AMENDMENT OF SOLICITATION/MODIFICATION OF CONTRACT			1. CONTRACT ID CODE	PAGE OF PAGES
			1 of 3	
2. AMENDMENT/MODIFICATION NO. <div style="text-align: center;">4</div>	3. EFFECTIVE DATE <div style="text-align: center;">3-Jun-2003</div>	4. REQUISITION/PURCHASE REQ. NO.	5. PROJECT NO. <i>(If applicable)</i>	
6. ISSUED BY US Army Corps of Engineers, Kansas City District 760 Federal Building, 601 East 12th Street Kansas City, Missouri 64106-2896		7. ADMINISTERED BY <i>(If other than item 6)</i>		
8. NAME AND ADDRESS OF CONTRACTOR <i>(No., street, county, State and ZIP Code)</i>		(X) 9a. AMENDMENT OF SOLICITATION NO. X DACA41-03-B-0002 9b. DATED <i>(SEE ITEM 11)</i> 4/28/2003 10a. MODIFICATION OF CONTRACT/ORDER NO. 10b. DATED <i>(SEE ITEM 13)</i>		
CODE FACILITY CODE

Access Control Facilities
Fort Leonard Wood, Missouri

The SOLICITATION is amended as follows:

SHEET TITLE: A313- WALL SECTION VOL. 1		
PROJECT: ACCESS CONTROL FACILITIES		
Drawn By:	DGV	AMED.4
Checked By:	VDR	2 OF 8

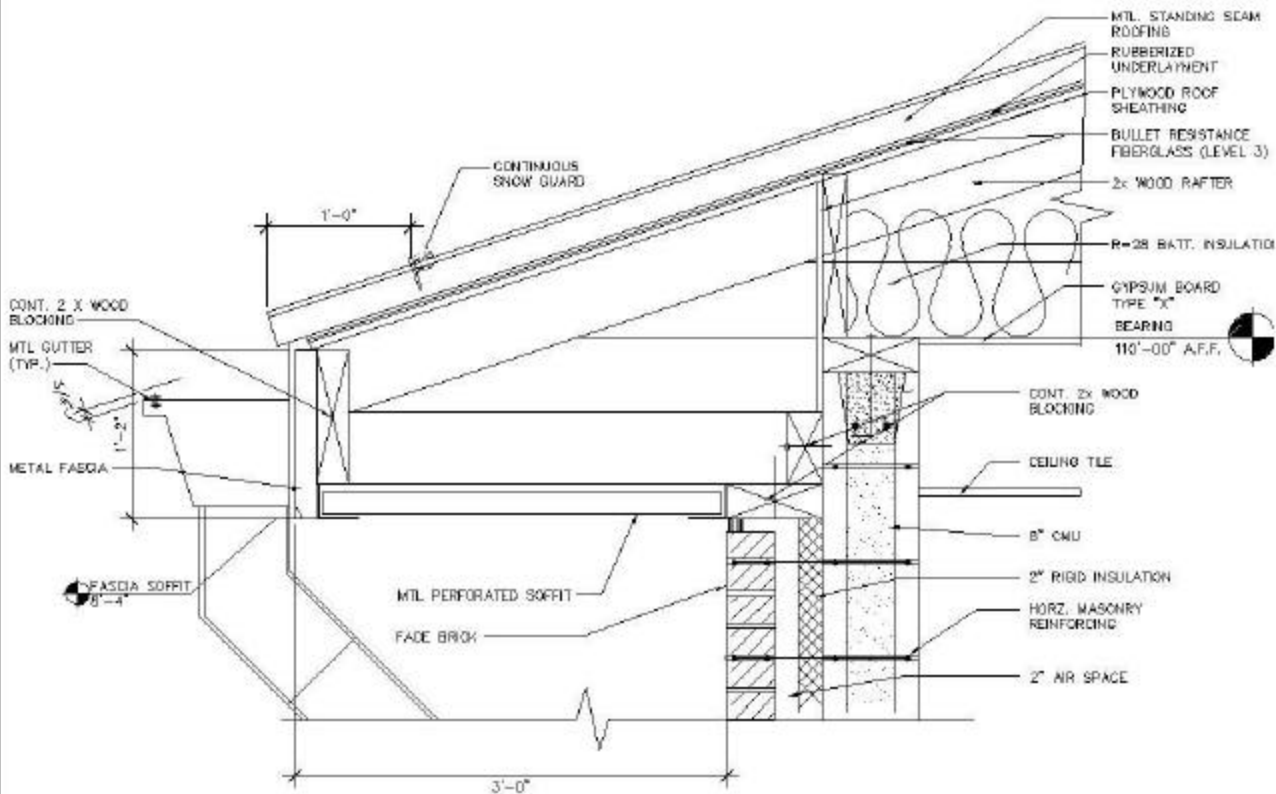
p. Volume 1 – North Gate, Sheet A313, Detail 1, Lockers:

The lockers are to be 60 inches tall with a 30-degree sloping cover plate. Detail is enclosed in this Amendment.

A521- EAVE DETAIL
VOL.1

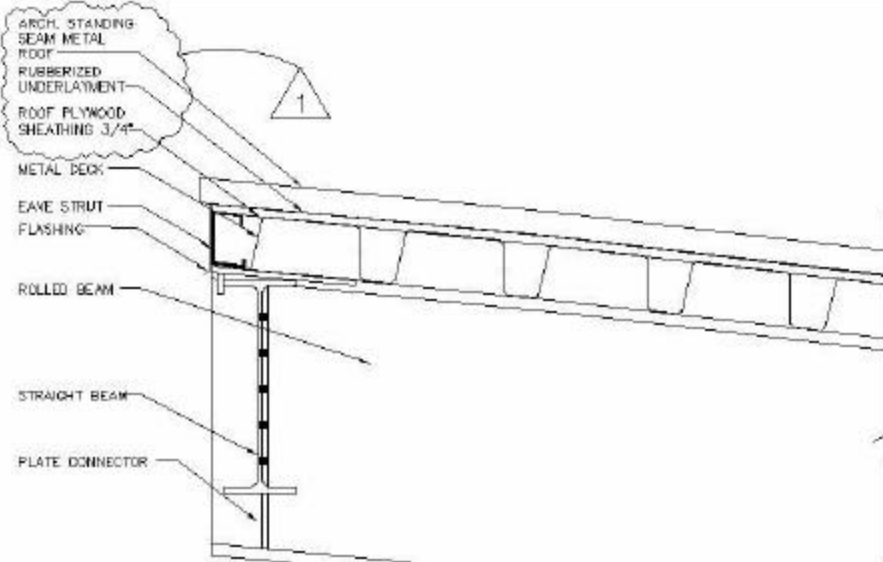
j. Volume 1 – North Gate, Monitoring Building, Sheet A521:

Disregard previously issued Eave Detail No. 3.

The roof system is as follows: Architectural standing seam roof panels with concealed clips and fasteners, over a rubberized underlayment, over bullet-resistant fiberglass panels, over plywood roof sheathing. Blanket insulation is to be installed at the bottom of the roof trusses. See new Detail in this Amendment.

ROOF DETAIL

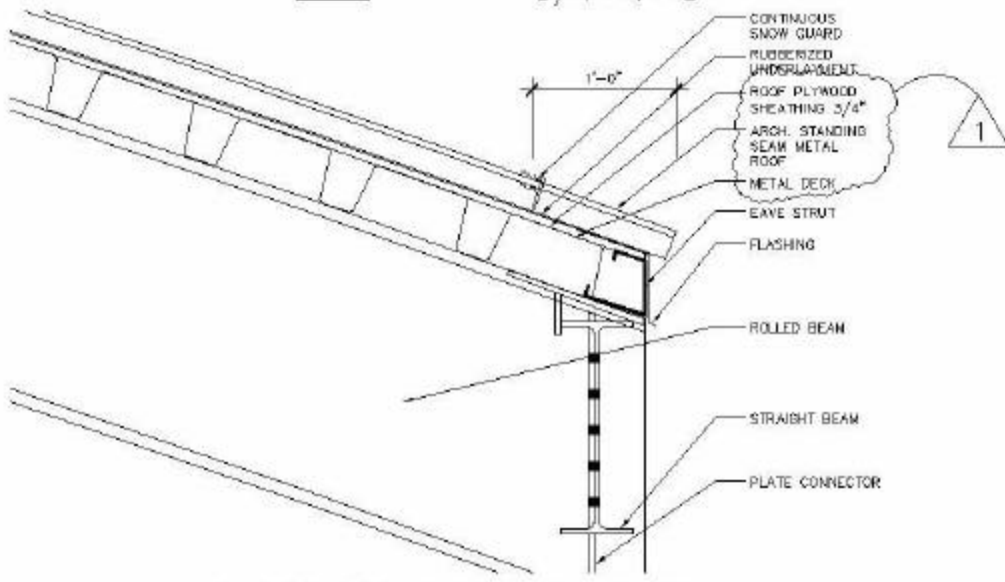
i. Volume 1 – North Gate, Visitor's Center/Guard Administration Building, Roofing System, Sheet A510:

Disregard previously issued Roof Details 1, 2, and 4.

The roof system is as follows: Architectural standing seam roof panels with concealed clips and fasteners, over a rubberized underlayment, over plywood roof sheathing, over roof metal deck, with rigid board Insulation on the underside of the metal deck.

See new Details in this Amendment.

SHEET TITLE:		
A550-MISC. DETAILS TRUCK CANOPY VOL.1		
PROJECT:		
ACCESS CONTROL FACILITIES		
Drawn By:	DGV	AMED.4
Checked By:	VDR	4 OF 8

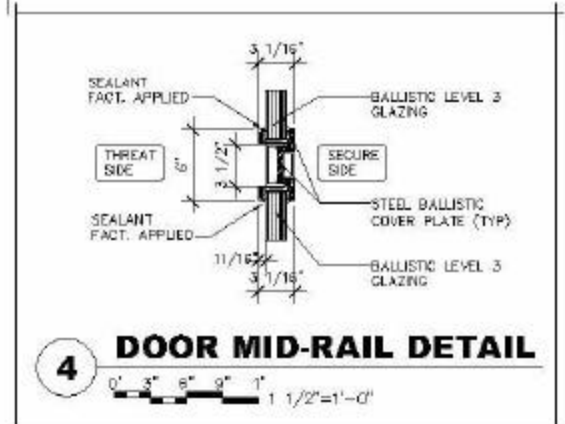
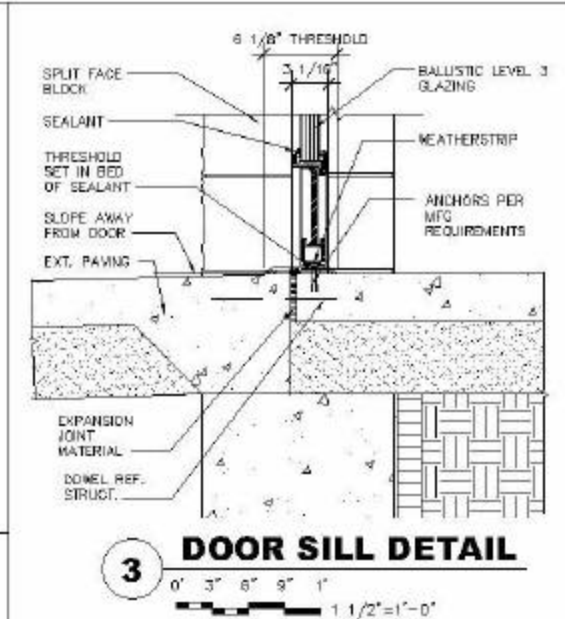
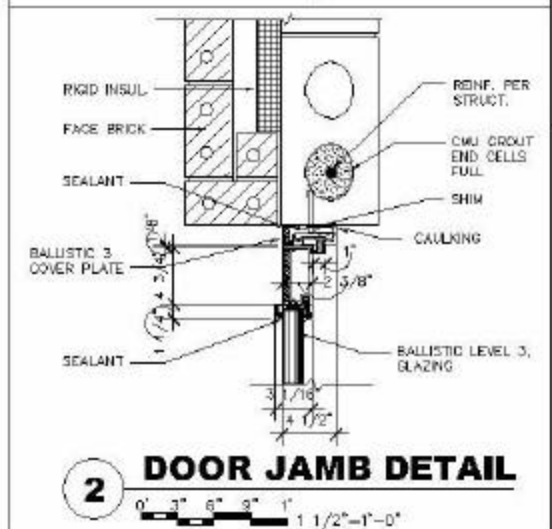
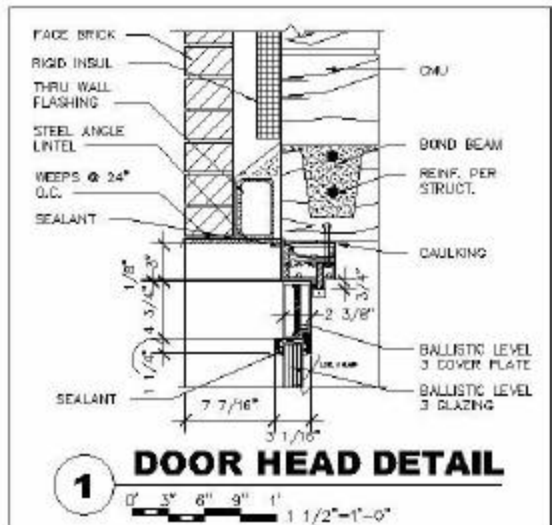
l. Volume 1 – North Gate, Canopies:

Disregard previously issued Details 1 and 2, on Sheet A550.

New Details 1 and 2 are included in this Amendment.

1 DOOR HEAD DETAIL

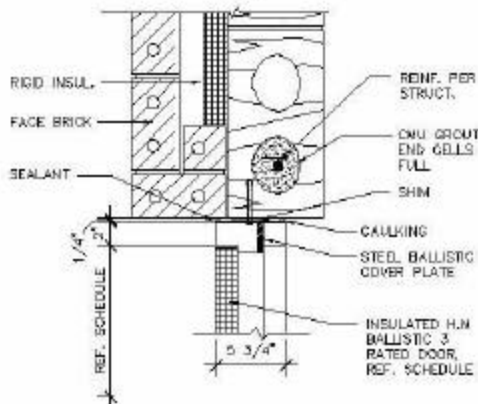
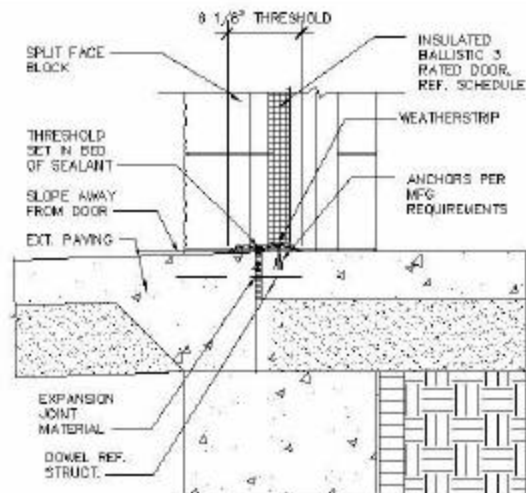
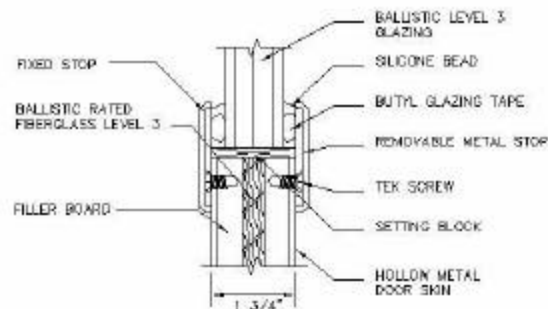
h. Volume 2 – South and East Gates:

Sheet A582, Details 1 through 3. Disregard indicated Ballistic Level 3 rated aluminum door and frame details. New details showing a hollow metal door, frame, and glazing have been developed and included in this Amendment.
